SUBJECT: COMMISSION AND BOARD NOTIFICATION OF POTENTIALLY RELEVANT AND MATERIAL LICENSE AMENDMENT IN THE MATTER OF THE GEORGIA INSTITUTE OF TECHNOLOGY RESEARCH REACTOR

Board Notification 95-15

SUBJECT: ISSUANCE OF AMENDMENT NO. 11 TO FACILITY OPERATING LICENSE NO. R-97,
GEORGIA INSTITUTE OF TECHNOLOGY RESEARCH REACTOR (TAC NO. M79563)

Amendment No. 11
License No. R-97

Figure 6.1 Georgia Tech Organization for Management and Operation of the GTRR. (Amendment 11).

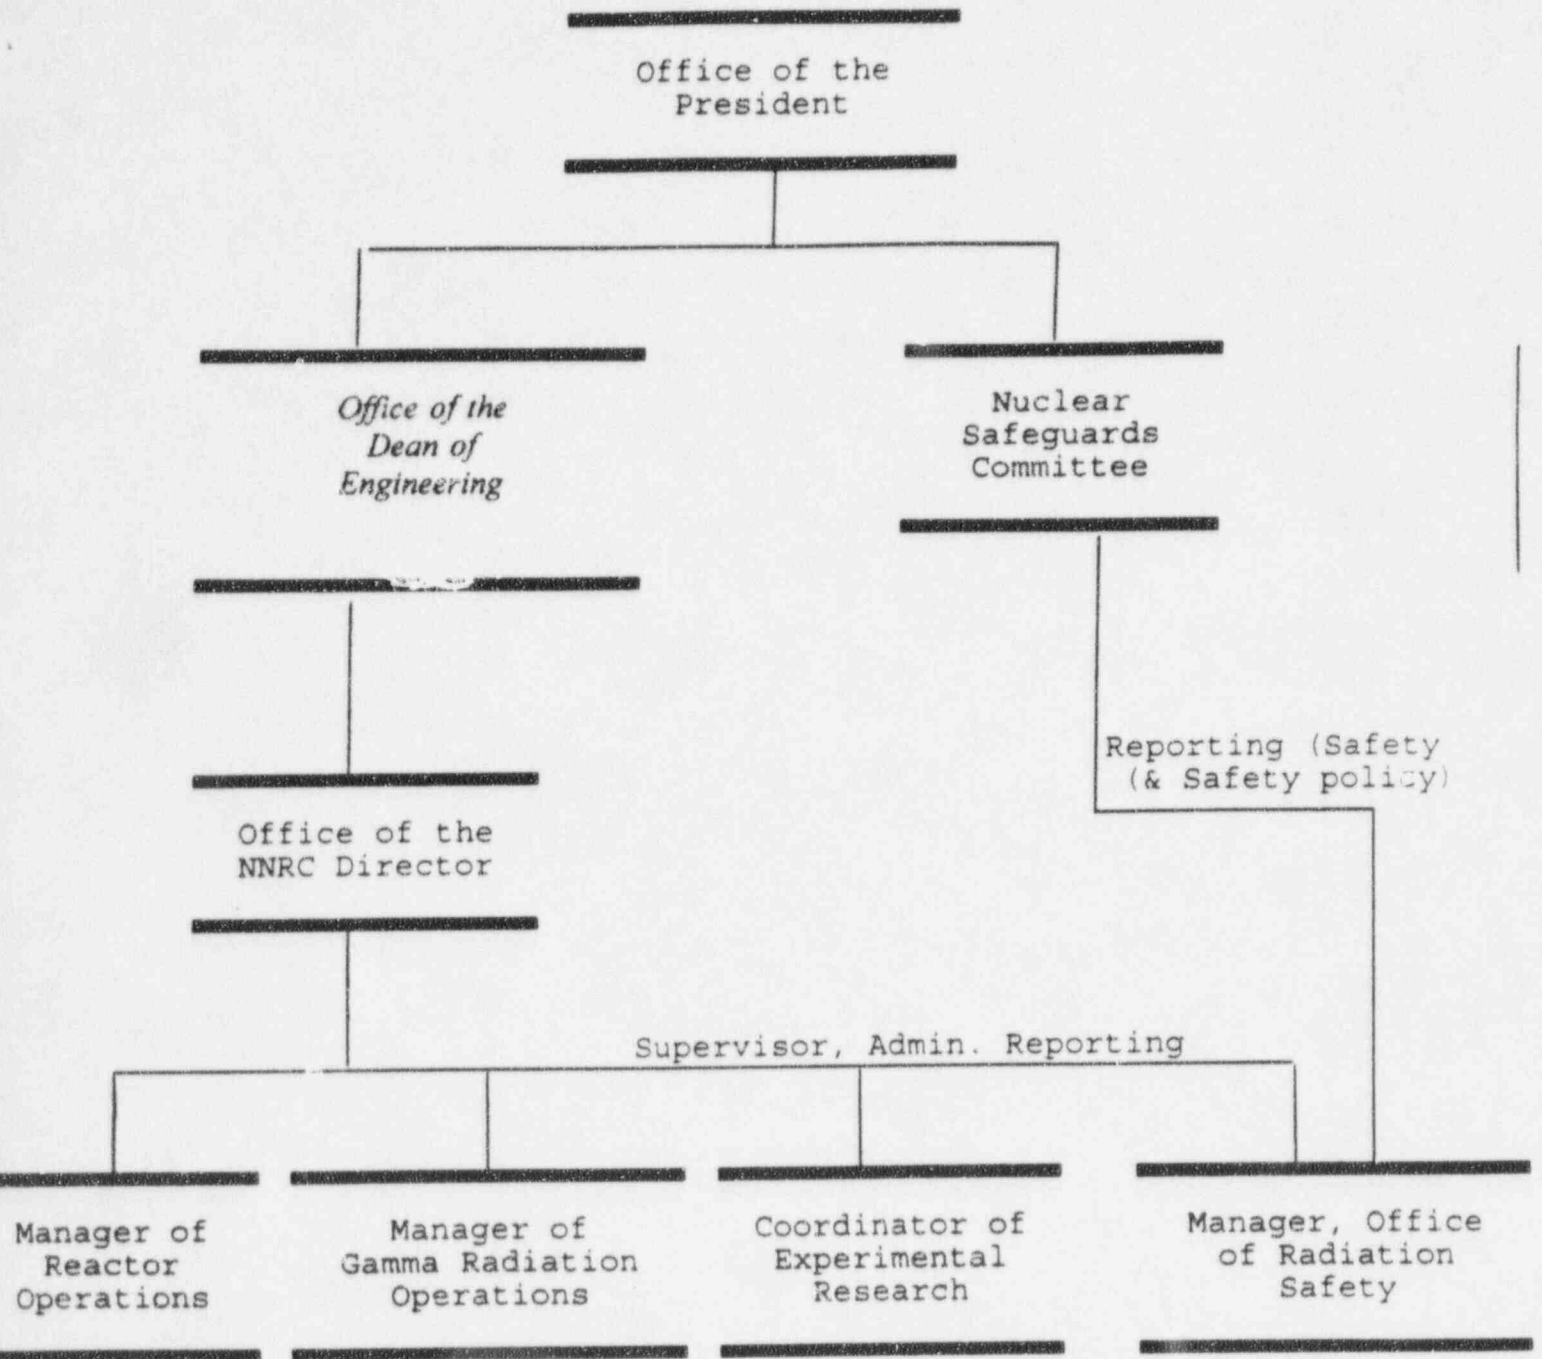
The current Technical Specifications indicate that the Director of the Neely Nuclear Research Center reports to the Vice President for Interdisciplinary Programs who reports to the President of the Institute. The licensee plans a reorganization, such that, the position of the Vice President for Interdisciplinary Programs will be eliminated and the Director of the Neely Nuclear Research Center will report to the Dean of the College of Engineering who reports to the President of the Institute. This reorganization plan is consistent with American National Standards Institute/American Nuclear Society Standard (ANSI/ANS) 15.1-1990, "Development of Technical Specifications for Research Reactors." The licensee indicated that the change does not involve changes in staff or financial resource allocation. Because the reorganization plan is consistent to ANSI/ANS 15.1-1990 and has no adverse effect on the reactor administrative organizational structure and function, the NRC staff finds the proposed change acceptable.

- a. The organization for the management and operation of the reactor shall be as indicated in Figure 6.1. The Director, Nuclear Research Center, shall have overall responsibility for direction and operation of the reactor facility, including safeguarding the general public and facility personnel from radiation exposure and adhering to all requirements of the operating license and Technical Specifications.
- b. The Manager, Office of Radiation Safety, shall advise the Director, Nuclear Research Center, in matters pertaining to radiological safety. He/she has access to the Dean of Engineering and/or the President of the Institute as needed.
- c. The minimum qualifications with regard to education and experience backgrounds of key supervisory personnel in the Reactor Operations group shall be as follows:
- (1) Reactor Supervisor
